RFP NO. 16DOT7001
RFP Due Date: 9 September 2016
Date Addendum Issued: 15 July 2016

RFP Addendum #2

Description: OVERHAUL OF P40 LOCOMOTIVES FOR THE CONNECTICUT DEPARTMENT OF TRANSPORTATION

AMTRAK
CLEARANCE DIAGRAM
D-05-1355 REV-B

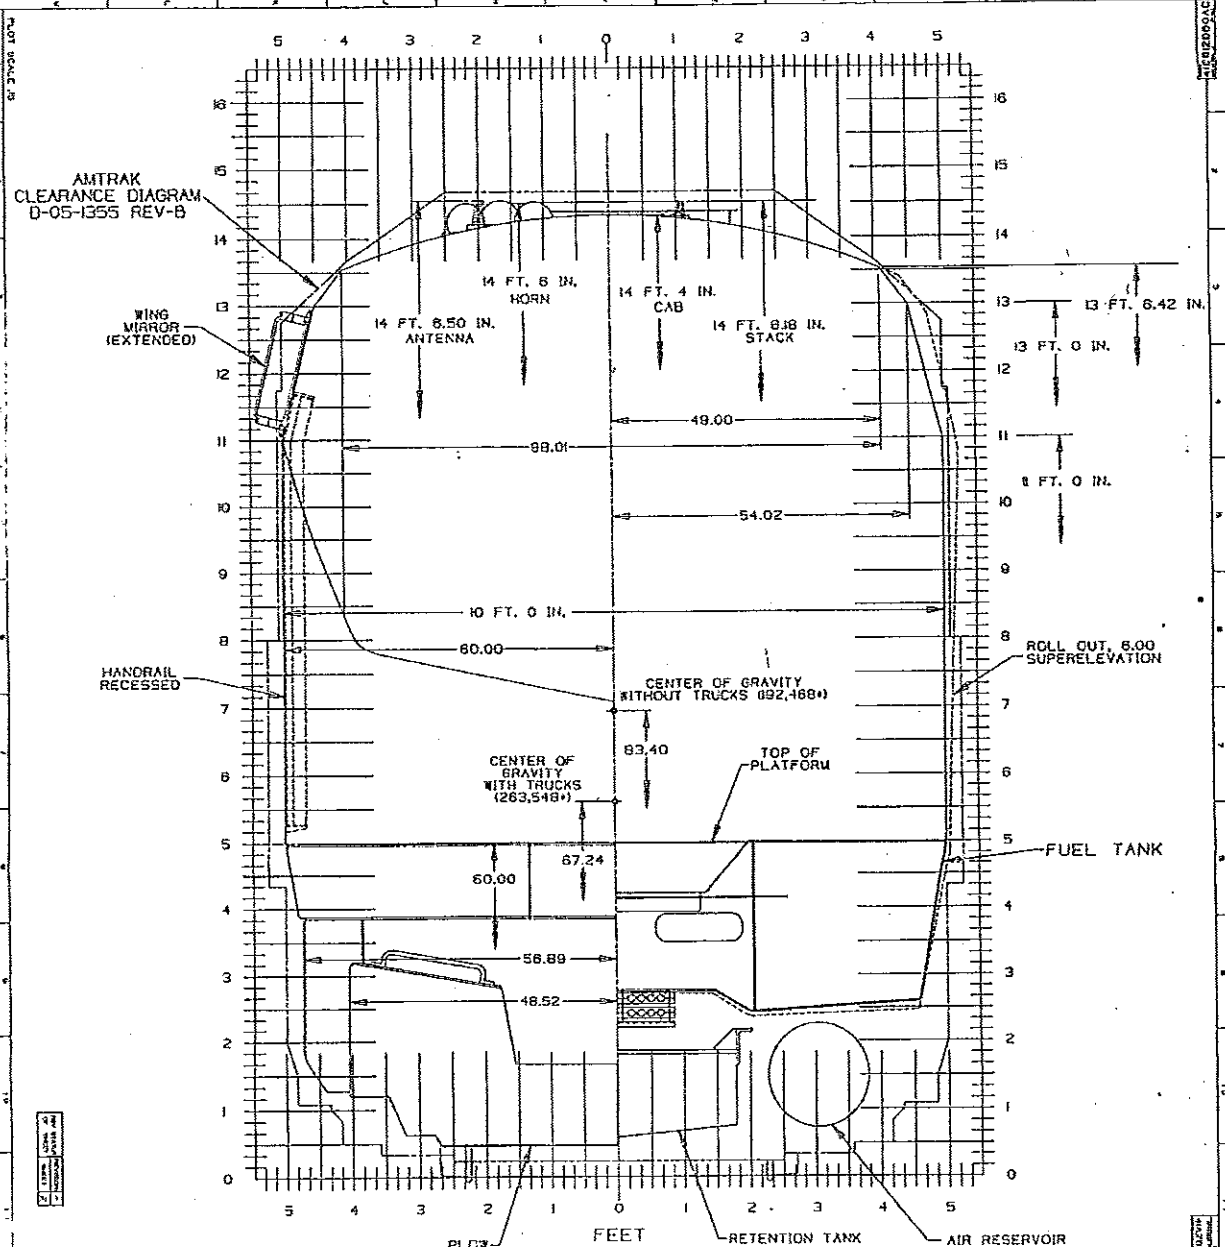
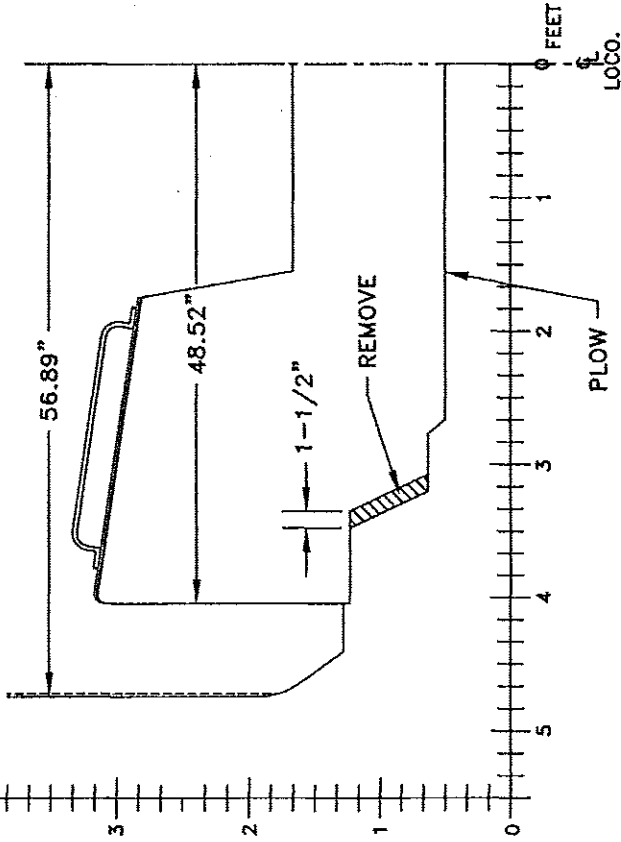
PROPOSER'S REQUEST: Has the railroad verified the heights of the P40 fleet by measurements against a standard template? We request CTDOT share the height data from top of rail for the various points on the locomotive such as the top of cab, top of air conditioner, top of inertial hatch, top of engine hatch, top of dynamic grid fan and top of Rad fan? In lieu of the previous height measurements, would CTDOT provide a drawing with these measurements depicted?

CTDOT's COMMENTS (if applicable): To CDOT's knowledge, the current SLE fleet is within our standard envelope. the ex-NJT locomotives may require minor modification to meet the requirement. Drawings are attached for reference
